# Japan Comments for Battery Durability GTR EVE38

8-9.October.2020

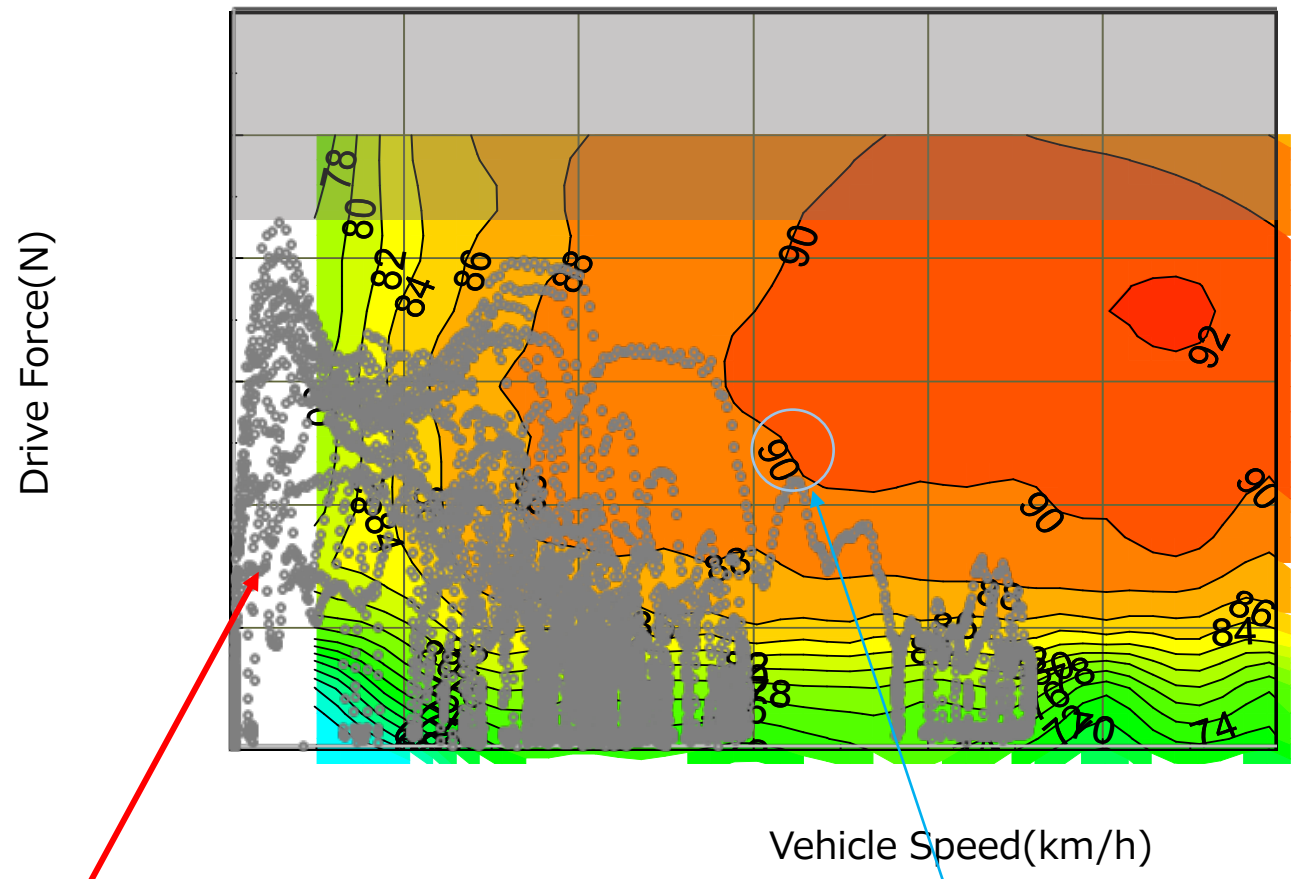
1) Definition of the “calculation cells” for the drive force/ veh speed operating area during certification (mapping), and allocation of operating time to each cell. The smaller cells, the more accurate, but the software resource is greatly increased.

2) The operating time during certification in each cell defines the weighting factor to be applied for that cell.

*Example: If 10% of certification cycle time happens in that cell, a 0.1 weighting factor is applied to the actual driving EC on that cell: EC \_ cell x 0.1.*

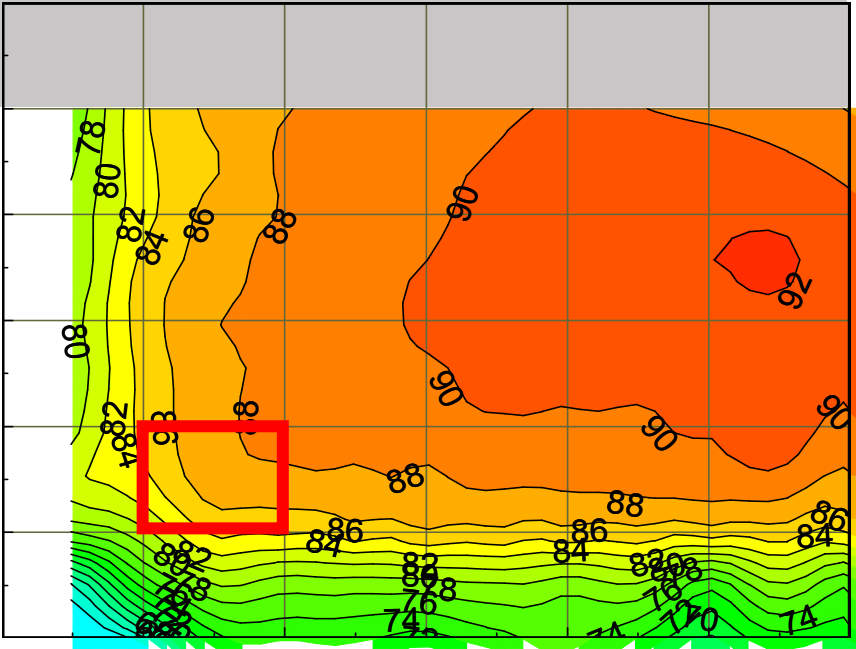
In the right figure, the power train efficiency in the cell in the red frame is distributed from 80% to 88%.

Efficiency is very different between 20 km \* 1000 N (80%) and 40 km \* 2000 N (88%) in the same cell.

so the EC error will vary depending on driving conditions.

**Finer cell granularity increases accuracy but increases ECU resources.**

Definition at GTR#15 Annex 8 para. 4.4.4.1

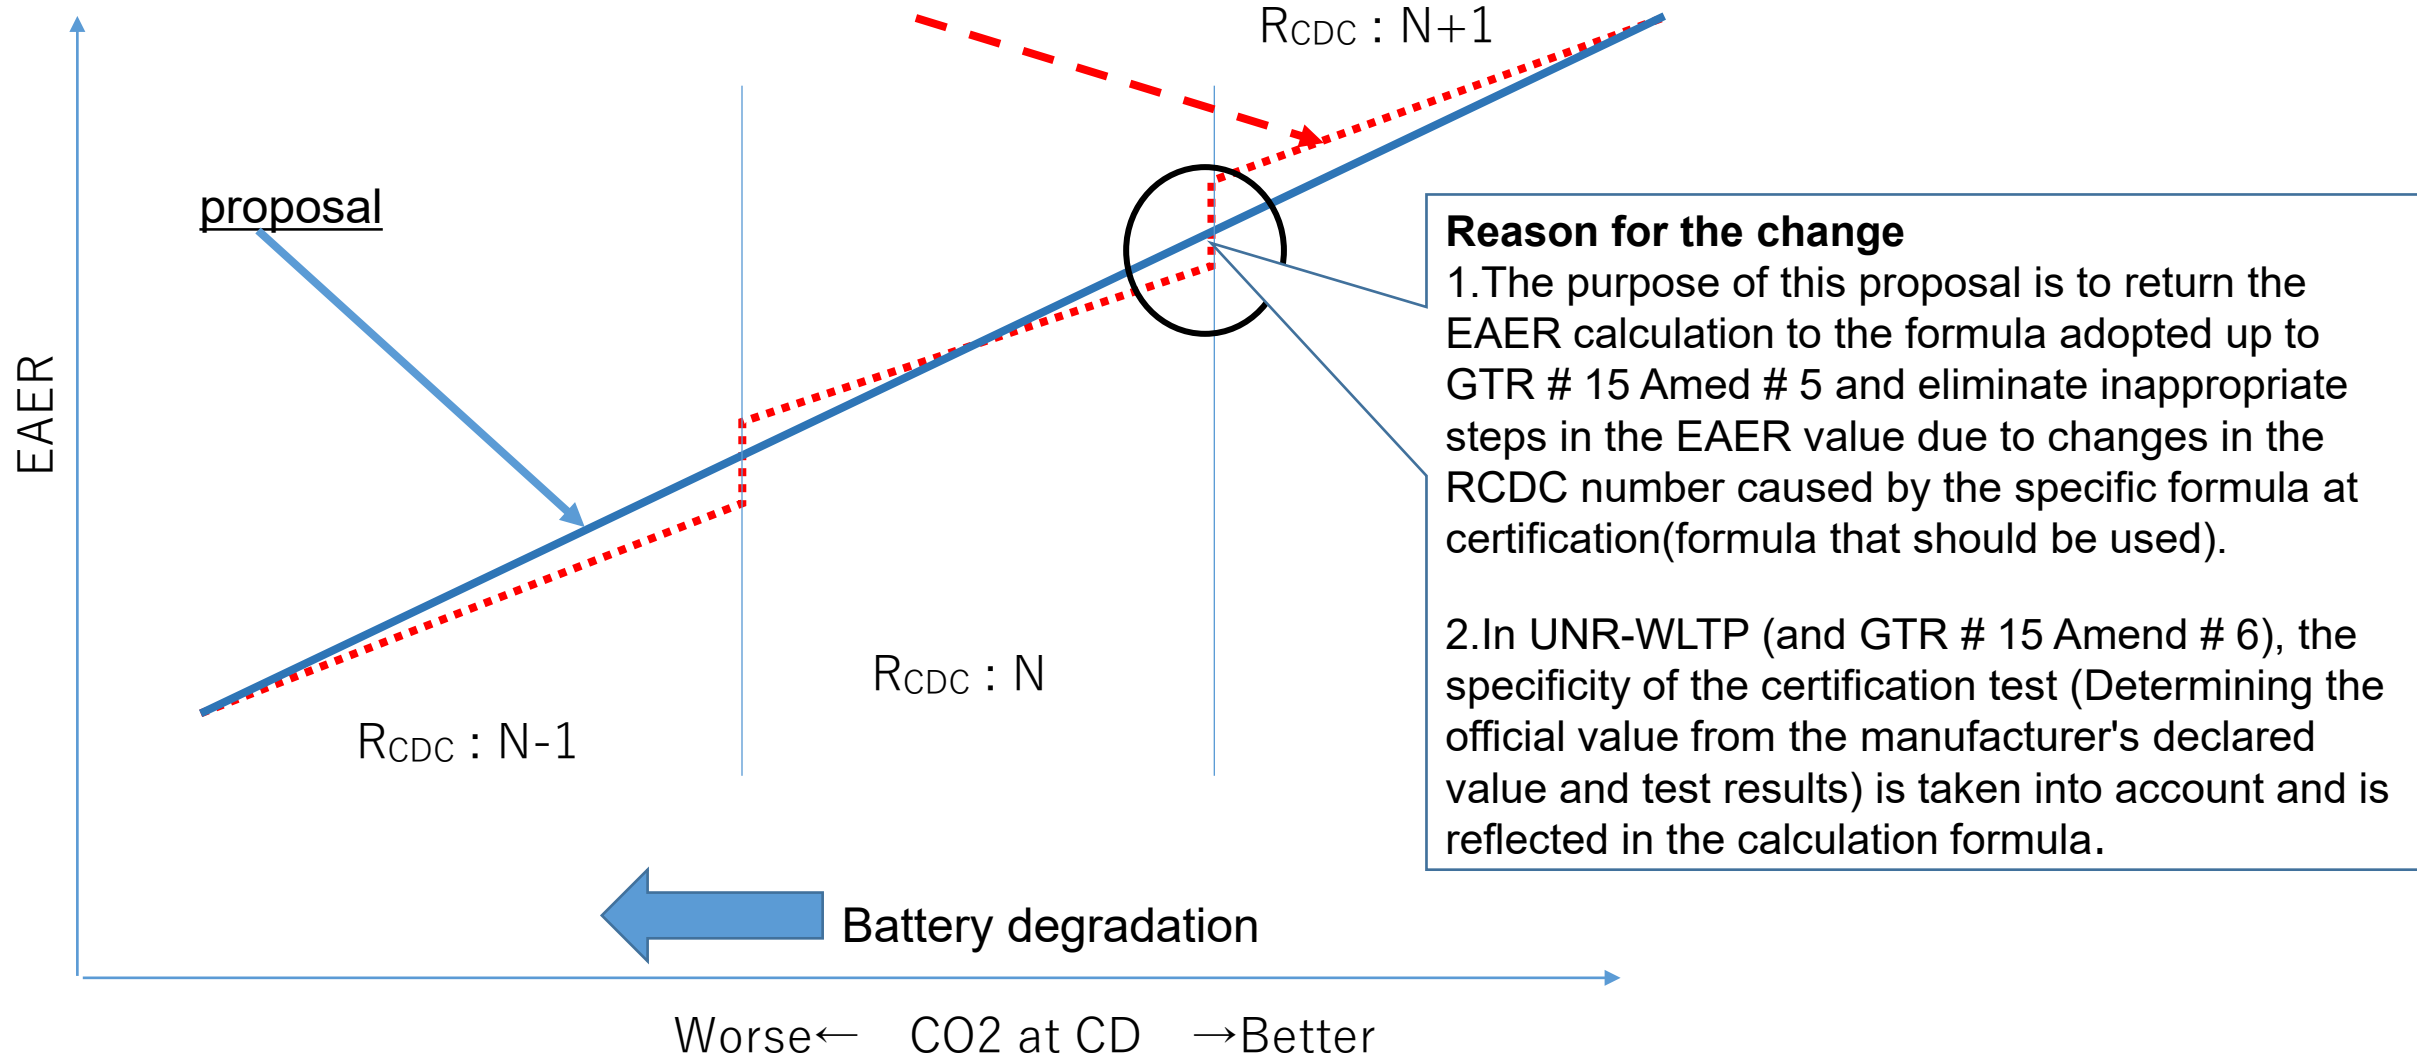
3. **EAER** : GTR#15 Annex 8 para. 4.4.4.1. shall be modified as follows

$$EAER = \left( \frac{M_{CO_2,CS, \text{ measured}} - M_{CO_2,CD, \text{ measured}} - \cancel{M_{CO_2,CD, \text{ declared}}}}{M_{CO_2,CS, \text{ measured}}} \right) \times R_{CDC}$$

Purpose of changing EAER: Prevention of step difference due to UF

EAER (As described in the CoC) at certification does not change, only the numerator definition at ISC \_ Part \_ A
